21-1485 Agenda Date: 11/3/2021

REPORT TO DEVELOPMENT REVIEW HEARING

Action on the new construction of a 3,789 square-foot six bedroom and four bathroom two-story single family residence with attached 495 square-foot attached one bedroom and one bathroom accessory dwelling unit at 143 Claremont Avenue

File No.: PLN2021-14093

EXISTING & PROPOSED ELEVATIONS

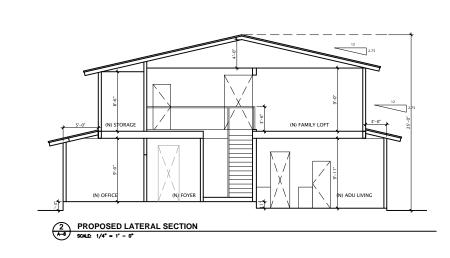
- 12. The City's design guidelines encourage low-pitched roofs or flat roof styles with generous roof overhangs for patio homes. The applicant is proposing a relatively low 2.75:12 roof pitch, two-foot rear and side roof eave overhangs for the first and second floors, and a larger four-foot roof eave projection over the front ground floor.

- 13. The project also proposes a five-foot deep by 16-foot wide balcony on the front elevation to be accessed from the second-floor family room area. The balcony is proposed to be constructed with frosted glass and cement railing to minimize privacy impacts to the yards of nearby patio homes.
